Technical Bulletin

45C Quad Viewmast® II Inner Upright Modifications to Accept New Style Cylinder Assemblies

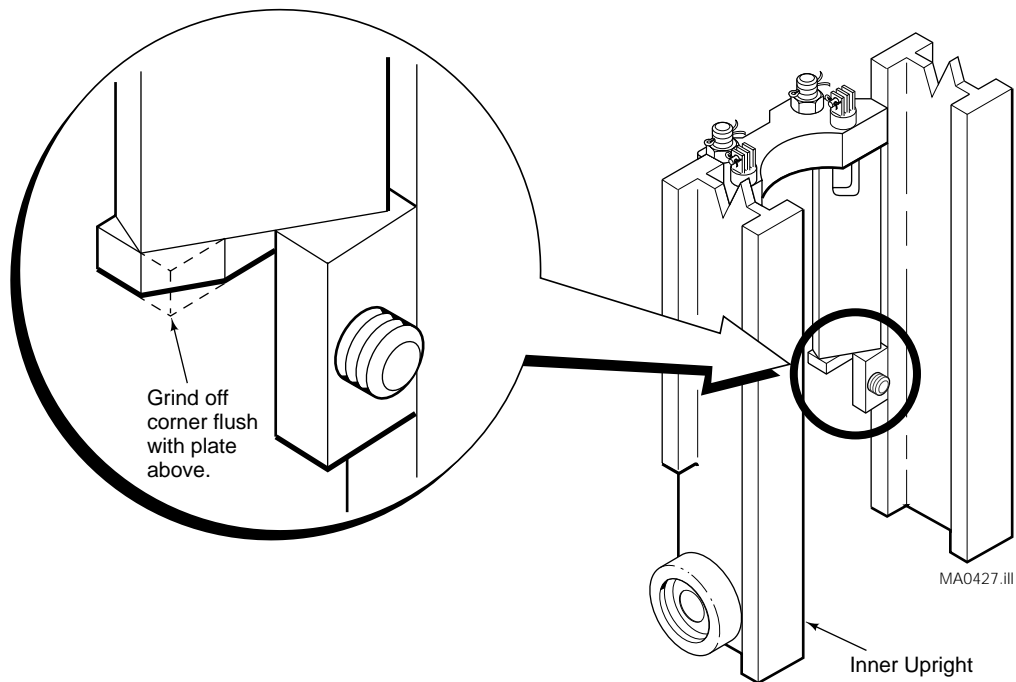
This sheet describes procedures to modify the mast inner upright to accept replacement cylinders with a new style hydraulic inlet port.

- 1 Remove the old cylinder from the mast. Refer to service manual part no. 669223, Section 5.1-5.
- 2 Grind or burn off the corner of the horizontal plate flush with the front surface of the vertical plate just above it.
- 3 Install the new cylinder then reassemble and adjust the mast as described in the service manual.
- 4 Raise and lower the mast through several cycles to check for interferences and correct operation.
